***Ducted Systems
Technical Services
Service Letter***

Letter: **YS-004-2019**

Subject: **16 SEER Heat Pump MOC (Fan Drive) Control Board Failure**

Product: **Residential YHM, CH16 & TH16 16 SEER 3 ton Heat Pump models**

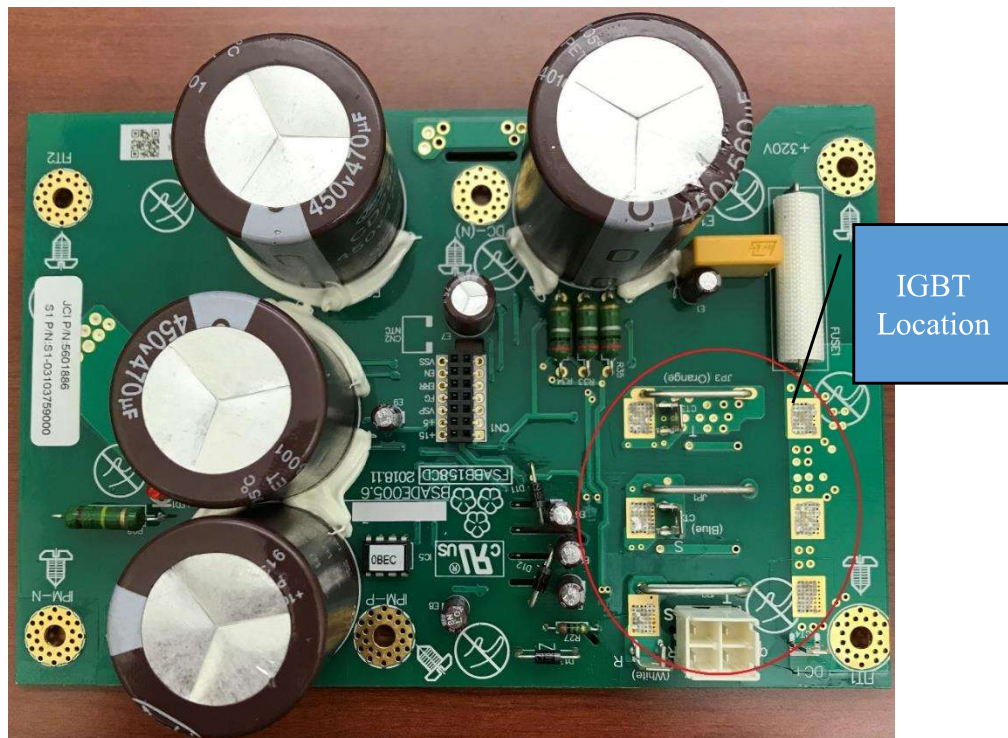
To help identify the new double sided board from the original single sided board, see photos below.

Original Single Sided Board

New Double Sided Board

The pictures above show the location of the IGBT's which are actually located on the back side of the control board, but the physical difference between the two boards is visible from the front. Note the elimination of the slots through the control board as well as the difference in the mounting pads for the IGBT's.
